**STATE OF DELAWARE
EXECUTIVE DEPARTMENT
OFFICE OF STATE PLANNING COORDINATION**

RE: PLUS review 2016-03-01; Summit Circle

Thank you for meeting with State agency planners on March 23, 2016 to discuss the proposed plans for the Summit Circle development. According to the information received, you are seeking review of a 14 unit subdivision on 18.138 acres in New Castle County.

Figure 1: NRCS soil survey mapping update in the immediate vicinity of the proposed construction

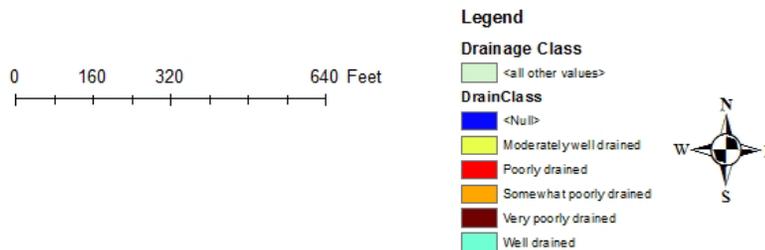
- Based on NRCS soils survey mapping update, Reybold (ReB) is the primary soil mapping unit mapped on subject parcel. Reybold is a well-drained upland soil that, generally, has few limitations for development. (Figure 1).
